WSU Bankstown Campus Proposal Peer Review of Transport and Traffic

Prepared for:
Canterbury-Bankstown City Council

13 September 2019

TPP Reference: 19158

Figure 15 Existing travel to work mode share (DZN 115710002)

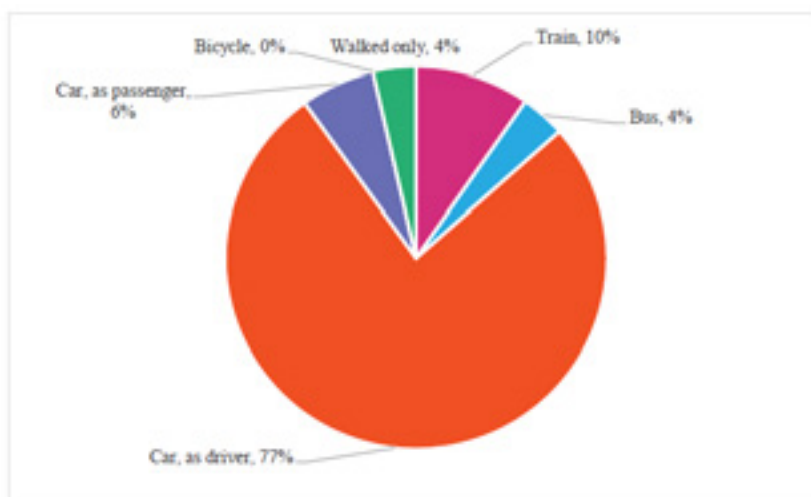
- Year 2016 Census data presented in Figure 15 of the TMAP indicates that 83 per cent of trips made by people employed within the selected Bankstown destination zone are car-based (77 per cent as car driver and 6 per cent as car passenger trips). Public transport only accounts for 14 per cent of trips, with the remaining four per cent by walking.

- The above data indicates that the Bankstown area is very reliant on car usage, even though the area is serviced by good public transport services, including rail and bus services from Bankstown Station.
- The Sydney Metro between Bankstown and the City will operate from Year 2024 at a peak frequency of 15 trains per hour in both directions (1 every 4 minutes). On this basis, it is expected that there would be some modal shift to train/metro once the Sydney Metro is operational.

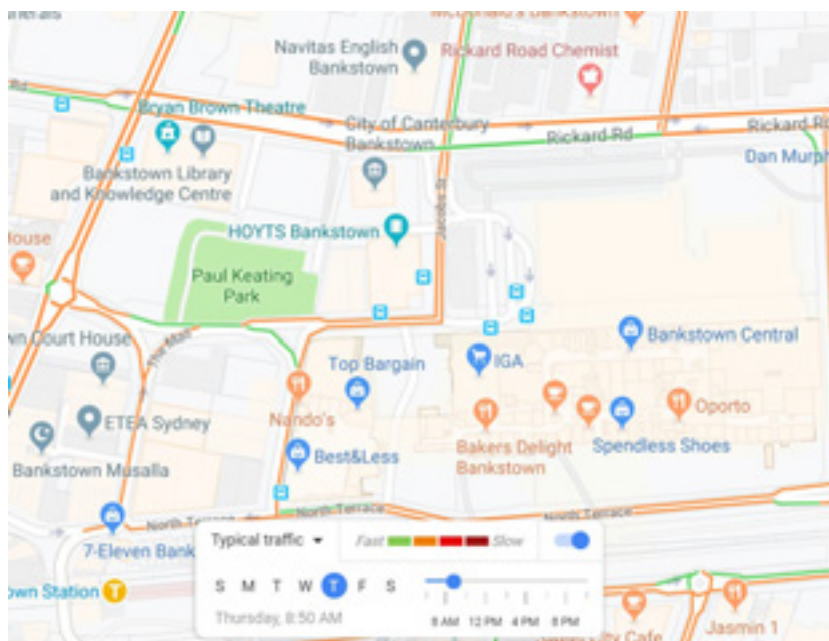
- Traffic surveys were undertaken at the two key immediate intersections on Wednesday 5 September 2018 between 7am and 10am and between 3pm and 7pm, as follows:
 - Rickard Road / Chapel Road
 - Rickard Road / Jacobs Street
- Traffic modelling was undertaken using SIDRA 8 modelling software at the above two intersections to assess existing conditions and future traffic conditions (including the full development of the site and traffic growth). A future background growth of 2.5 per cent on Rickard Road in the AM peak has been adopted in the traffic assessment based on future mid-block traffic volumes from the draft Bankstown Complete Streets project.

- Based on the modelling outputs, only Year 2018 has been assessed (i.e. no future year scenario). It is recommended that a +5 or +10-year future case scenario be assessed with and without the proposed development.

- The modelling outputs indicate that the average queue on Rickard Road on approach to Chapel Road is 2-3 vehicles in the AM peak and 5-8 vehicles in the PM peak.

- No queue length data is provided. It is recommended that queue length data is collected to assess the validity of the traffic models.
- Analysis of google congestion maps indicate that speeds along Rickard Road are not “free flowing” but with some congestion during the AM and PM peak periods. This data is generally interpreted as traffic queues for practitioners in the absence of queue length data. The orange line denotes that travel speeds are less than the posted speed limit, such that queues are interpreted as half the length of the orange line. Therefore, this suggests that the queue lengths modelled do not match the google congestion map data. See below.

Figure 3.1: Overall Transport Mode Split (2014)

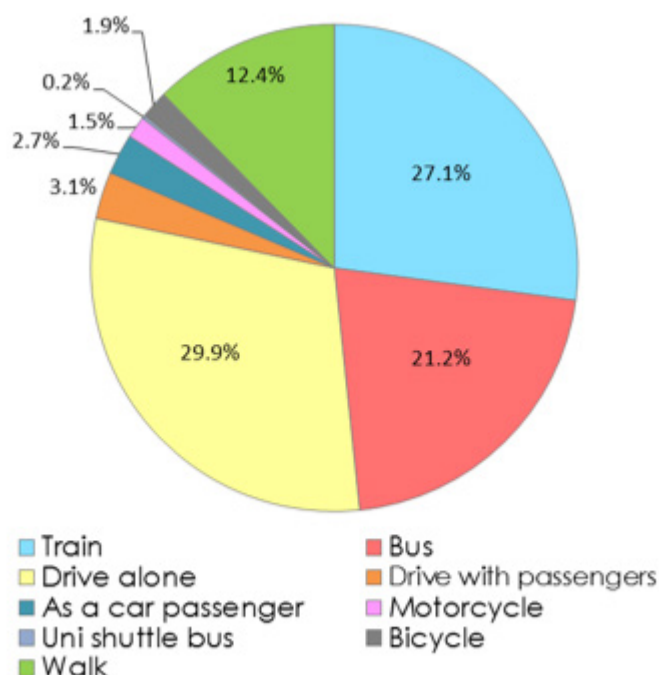
On this basis, a car driver mode target of 15 per cent is considered a bit low for staff when compared to the other universities and TAFE sites and the existing high car usage in the Bankstown area based on existing 2016 Census data.
